**RE: B14001697
BAT Plan
11200 Independence Way, Lot 67**

PLOT PLAN FOR BAT INSTALLATION AND PERCOLATION CERTIFICATION PLAN
LOT 67
HOMWOOD CROSSING
LIBER 9808, FOLIO 204
PLAT No. 18245
TAX No. 05-443326
FIFTH ELECTION DISTRICT
HOWARD COUNTY, MARYLAND
ADDRESS: 11200 INDEPENDENCE WAY
ELLCOTT CITY, MARYLAND

SITE PLAN FOR BAT INSTALLATION
LOT 67
HOMEWOOD CROSSING
LIBER 9808, FOLIO 204
PLAT No. 18245
TAX No. 05-443326
FIFTH ELECTION DISTRICT
HOWARD COUNTY, MARYLAND
ADDRESS: 11200 INDEPENDENCE WAY
ELLCOTT CITY, MARYLAND

TRENCH/DRAINFIELD DATA

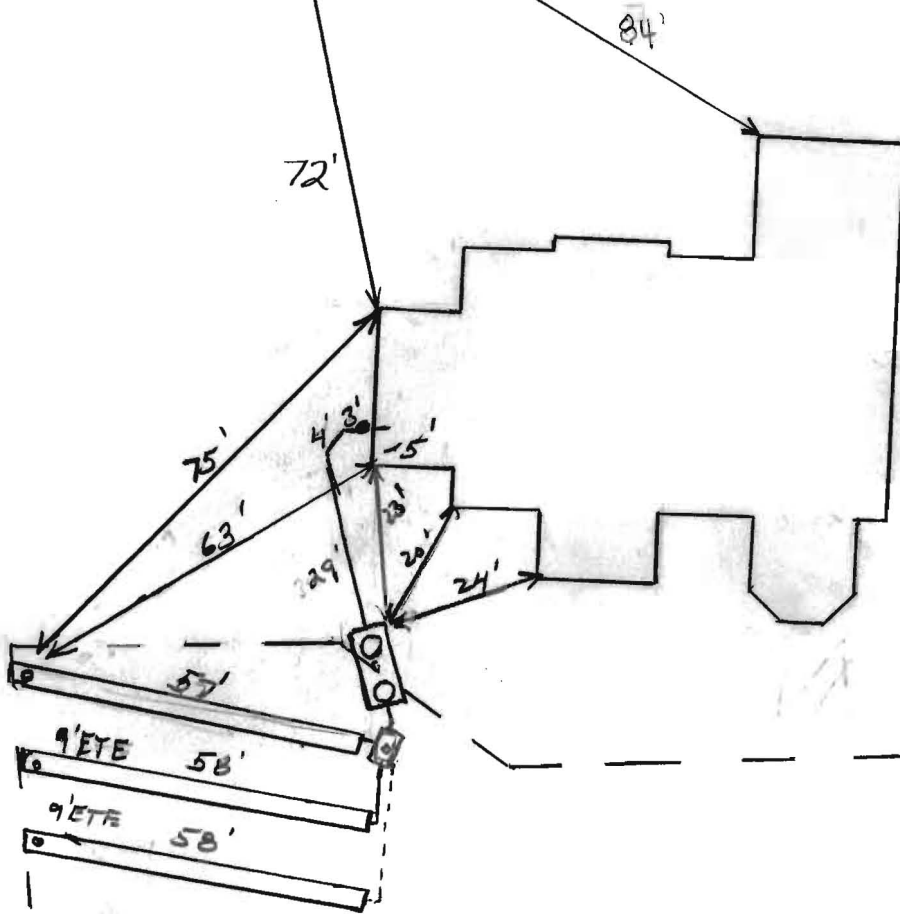
3/3/2015 Set the tank and dist. box similar to the plan. Install three 57' trenches on contour towards Homewood Road. (BB)

3/10/15 Foge's digging out from house. Will not start on trenches b/c of rain coming. (CC) 3/12/15 Tank set. Sewer house installed to tank. Store under pipe. Very muddy conditions. Trenches complete. Need more stone in last 20' of top trench. Need Dbox network + levelability. (KW) (PM) Dbox leveled. Dbox network installed. OK to cover work. Need RAT start-up (KW)

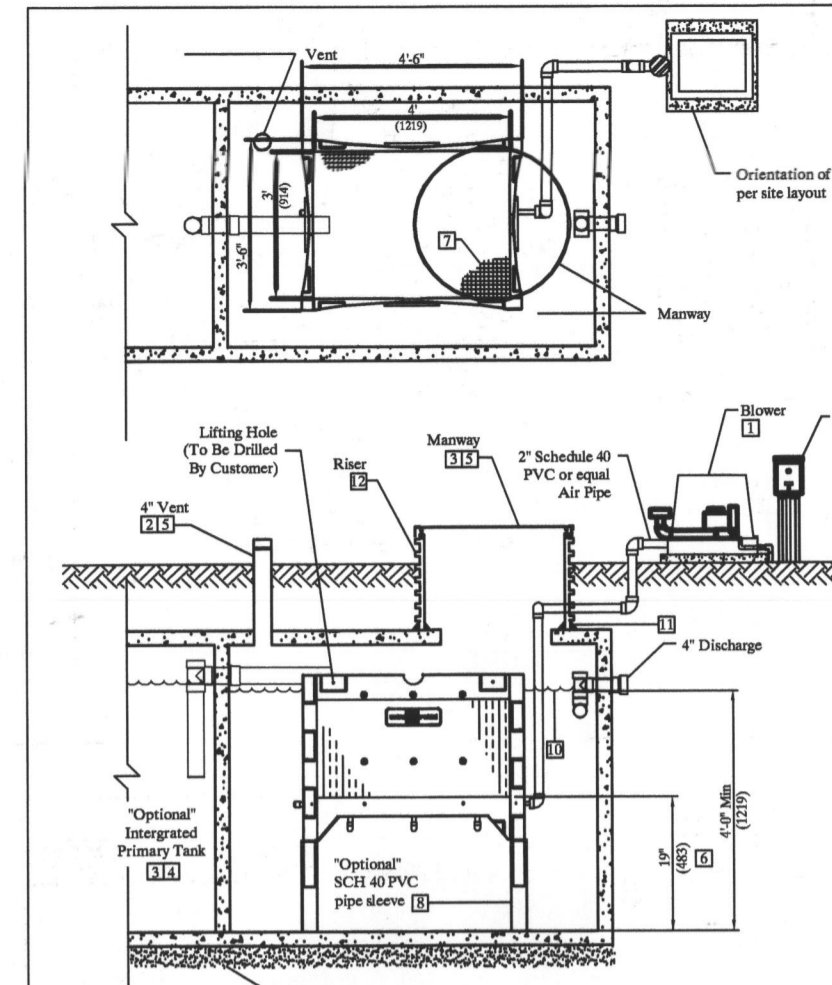
Hello. We have the BAT plan and a well permit for this lot. It looks like the BAT plan was a hybrid with a revised perc cert. Unfortunately, the proposed well locations are not acceptable. This lot along with lot 66 have well areas downgradient of the septic area on lot 44. In order to minimize the impact, we conditioned the three lots so that the septic system for 44 is to be installed at the farthest part of the area away from lots 66 and 67 and the wells on those lots are to be drilled in the farthest part of the wellboxes away from the septic area. To that end, we will not approve a revision to the well areas that bring the wells closer to directly downgradient of the septic area on 44 than what was already approved. If you want to get rid of the box to accommodate the driveway, you could put one well in the top right corner of the box by Homewood Rd and still stay 100' from the SDA (this will be the first well location) and keep alt #2 in the other corner of the existing box on the other side of the driveway. The existing well will become alt #1.

We will need a revised perc cert without the BAT plan stuff on it showing the proposed well locations along with perc test hole locations and the proposed septic area revisions with a Health Officer signature block. We can't release a well permit until the perc cert is signed. We will want a revised well exhibit showing the three well sites and only stake in the field the initial well site in the top corner. Please also clearly indicate on the well exhibit that the top right well site is the initial well site to be drilled.

From there, we will need the BAT plan revised to show the revised septic area and well sites with the existing well in its field located drilled spot. The BAT unit will have to be moved to stay 100' from the well sites. Thanks

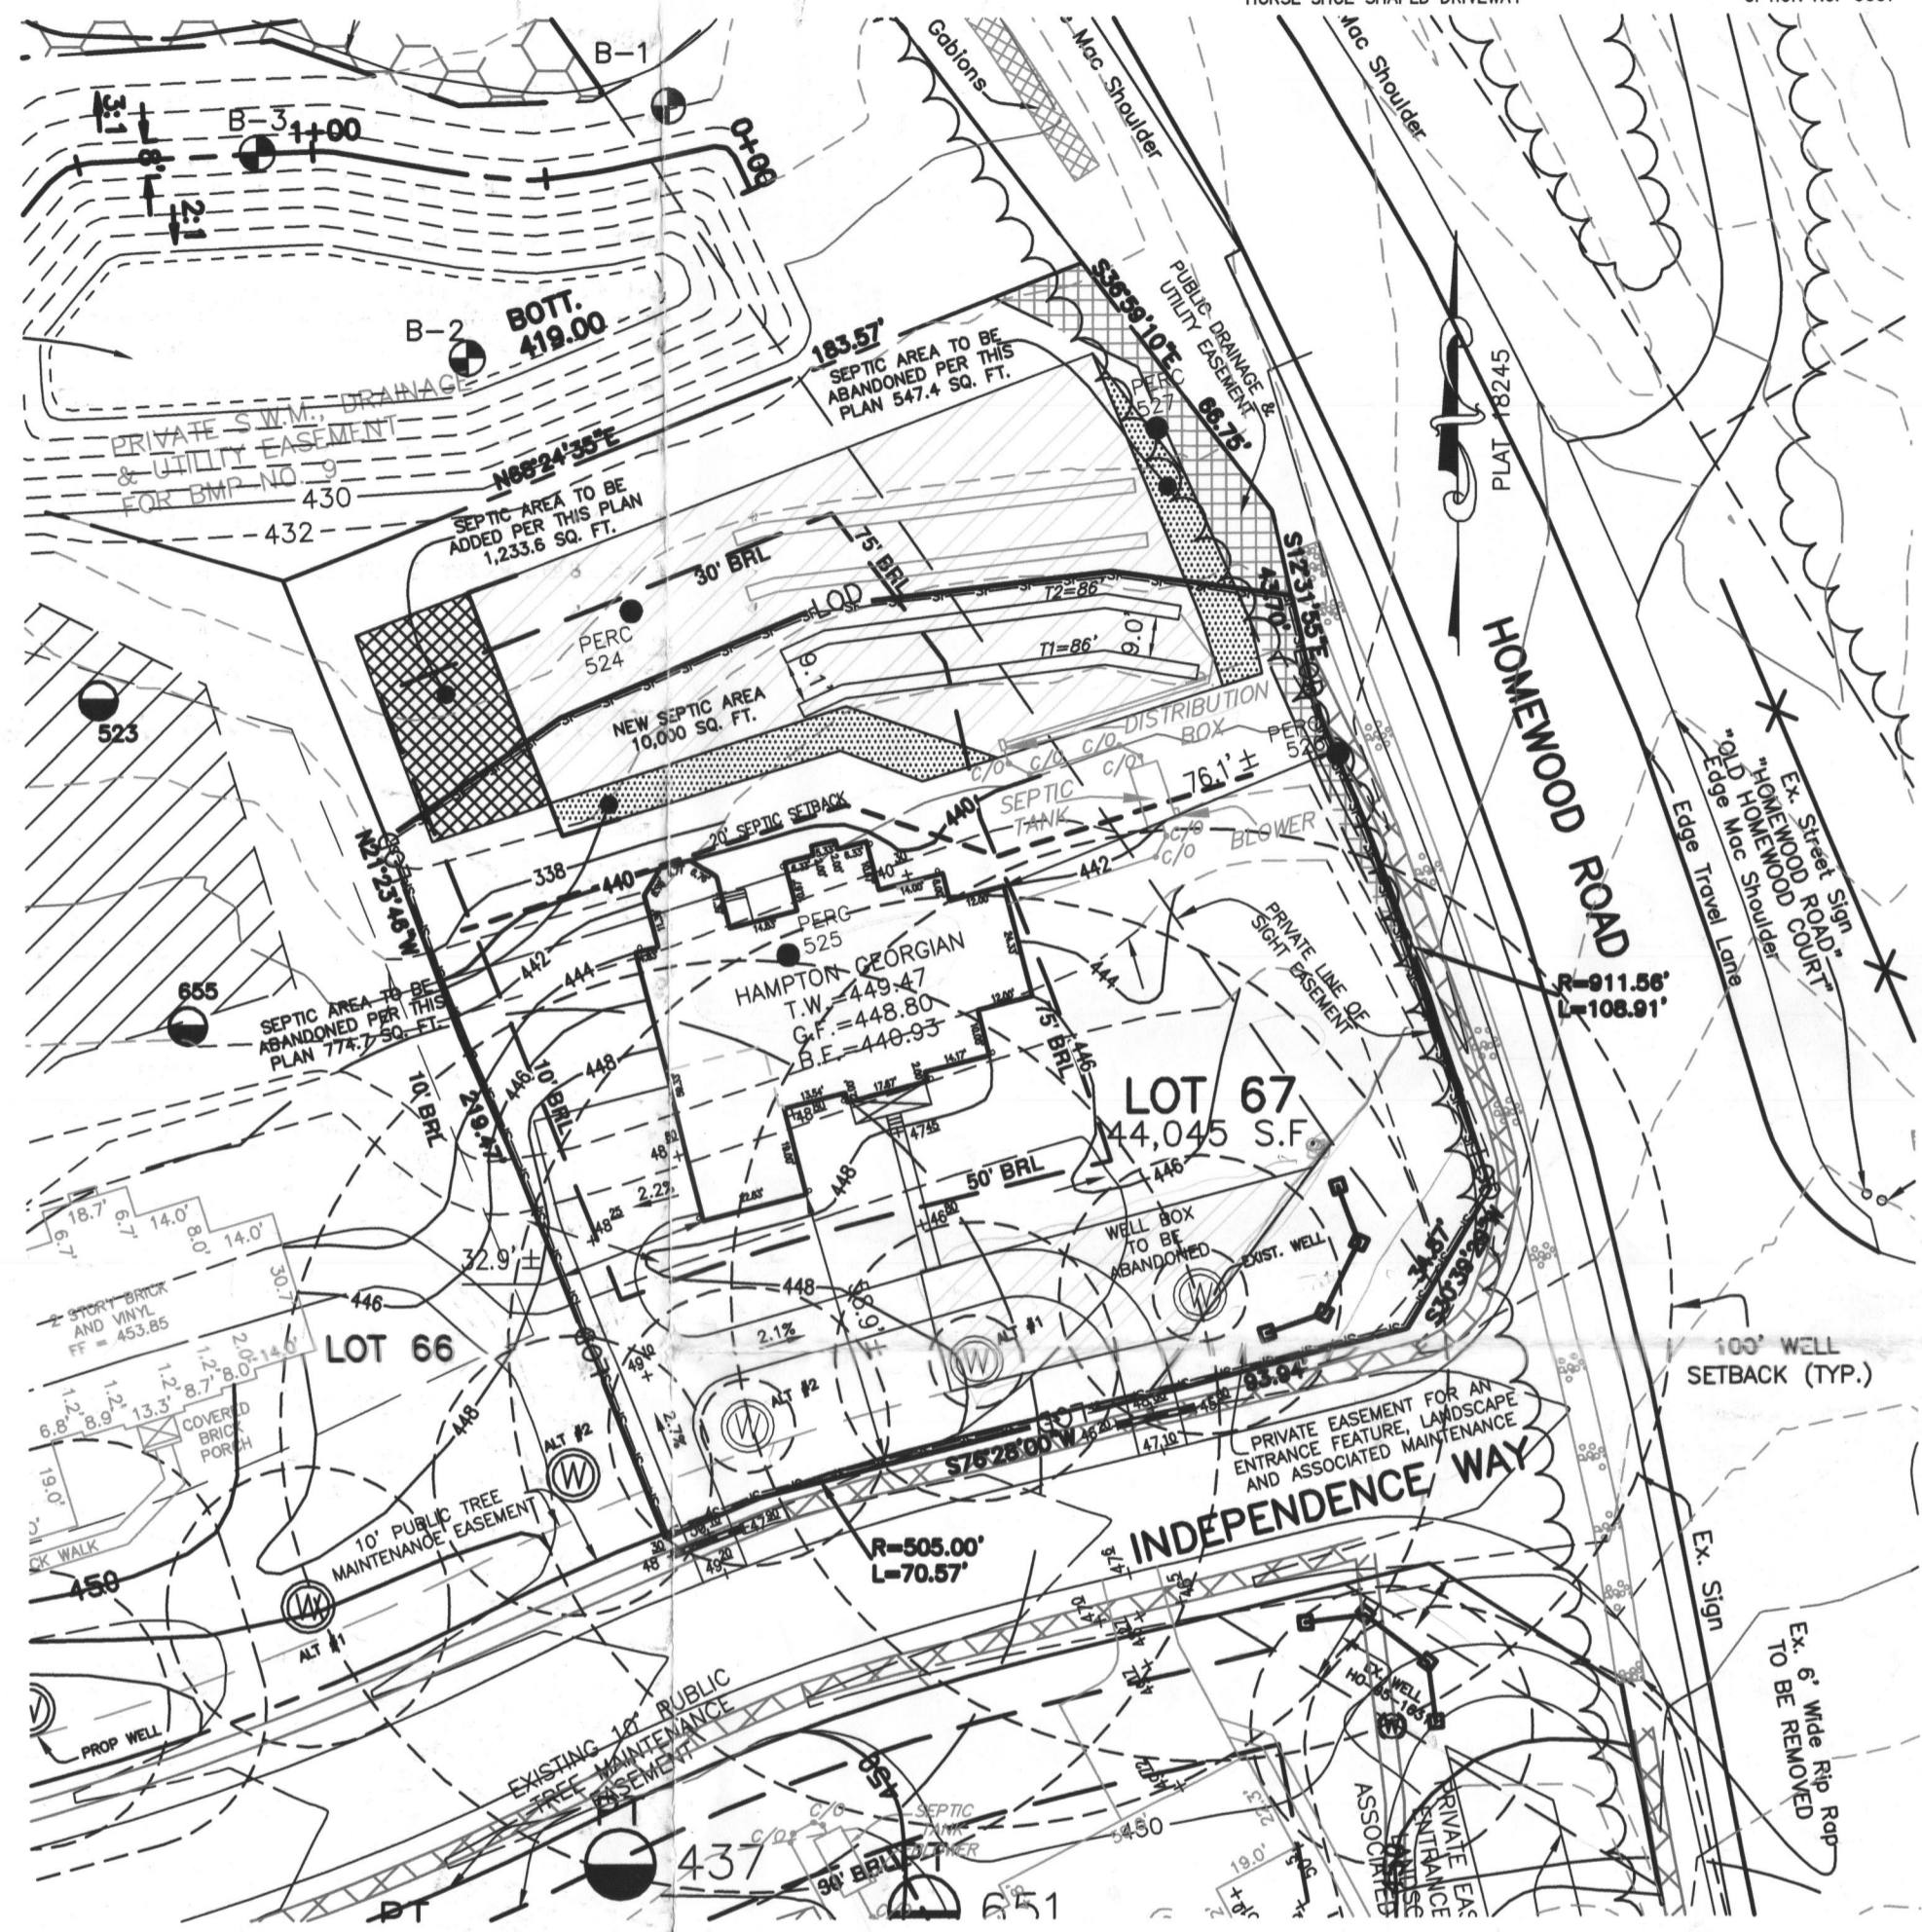
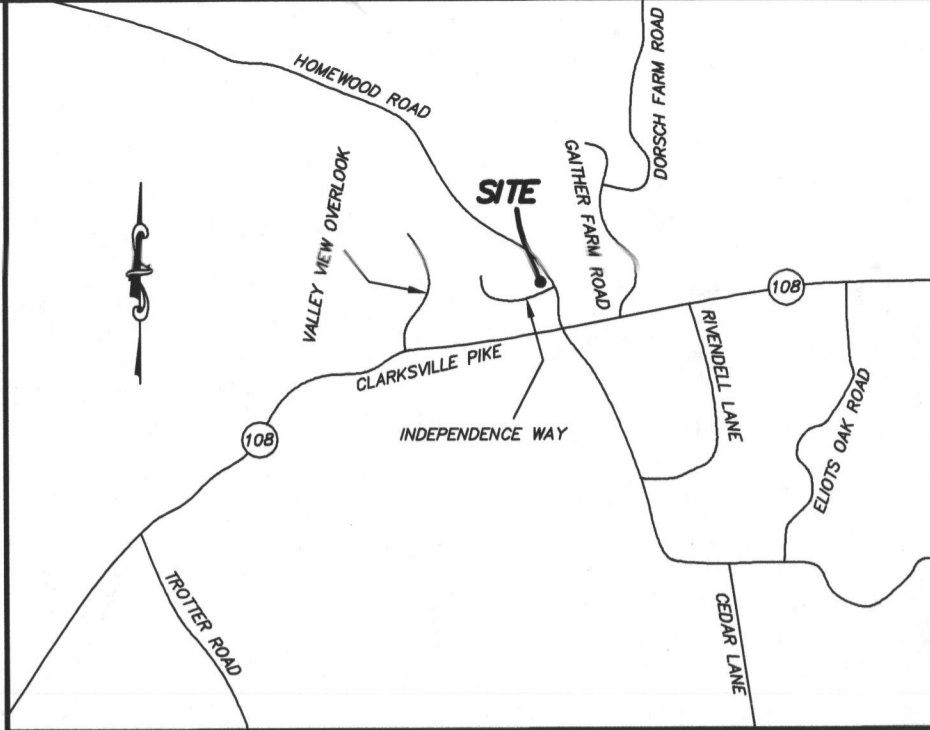
This letter is in response to the BAT Plan submitted for 11200 Independence Way, Lot 67. Upon review of the plan, a couple of items need to be added or changed on the plan. Please revise the plan to include the following:

- 1.) Add well tag number on site plan drawing next to actual well location.
- 2.) Septic tank is less than 20 feet from corner of house. Relocate septic tank to meet the 20 foot setback to house foundation.
- 3.) Trenches are less than 10 feet apart. Show trench separation at 10 feet.
- 4.) Trench # 2 is not on contour. Revise plan to show trench on contour.
- 5.) Revise trench design so T1 maximizes upper area if reasonable.
